PROJECT
RESERVE AT THE BALLPARK, PHASE II, AKA REVEL AT THE BALLPARK
2885 CRESCENT PKWY
SMYRNA, GA 30080

DATE **05/22/2017**
JOB NUMBER **1493101**
DRAWN BY **EKS/NB**
CHECKED BY **CW**
SHEET TITLE **BUILDING 1000B - PROJECT LEVEL 2**
SHEET NUMBER

A1-12B

COMMENTS **BUILDING PERMIT RE-SUBMISSION**
30X42 © 2017 The Preston Partnership, LLC

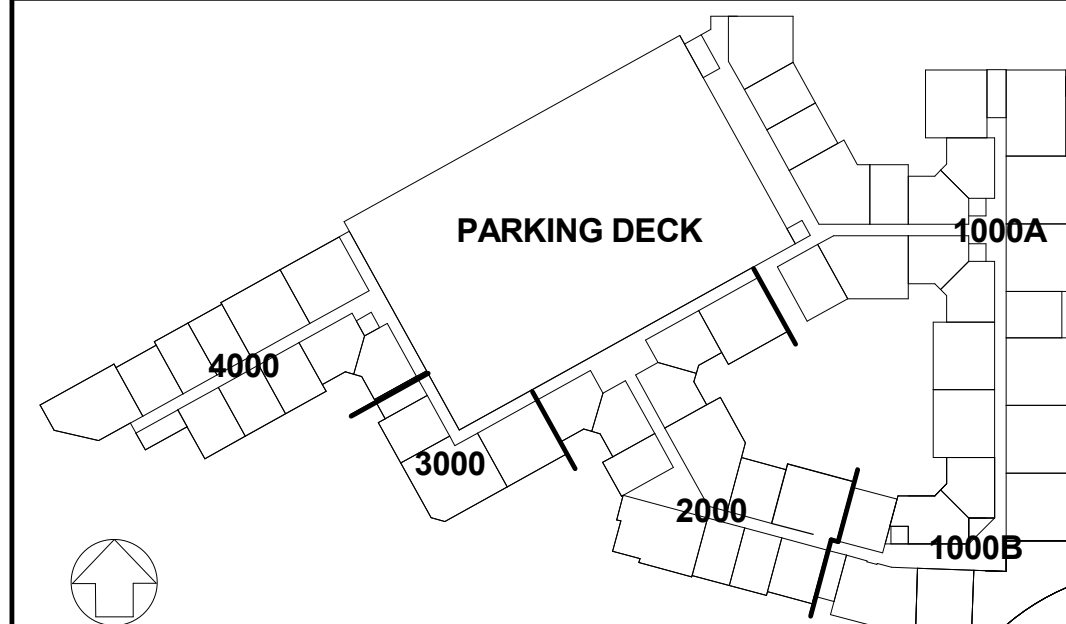
REVISION SUMMARY #1
A. ADDED EGRESS DOOR FROM CLUB ROOM. SHIFTED RAMP PL. AN EAST TO ACCOMMODATE DOOR.
B. CHANGED EGRESS DOOR FROM COURTYARD TO B27
C. CHANGED STAIR 2 TO STAIR C.
D. RECONFIGURED CORRIDOR. ADDED ELEVATOR LOBBY. REMOVED STORAGE RM. SHIFTED MECH RM. ADDED DOOR TYPE B38

REVISION SUMMARY #2
A. CHANGED DOOR B12 TO DOOR B45
B. ADDED MECH ROOM

REVISION SUMMARY #5
A. ADDED COL. GRIDS
B. ADDED COLUMNS
C. CHANGED WINDOW TYPE TO W5F
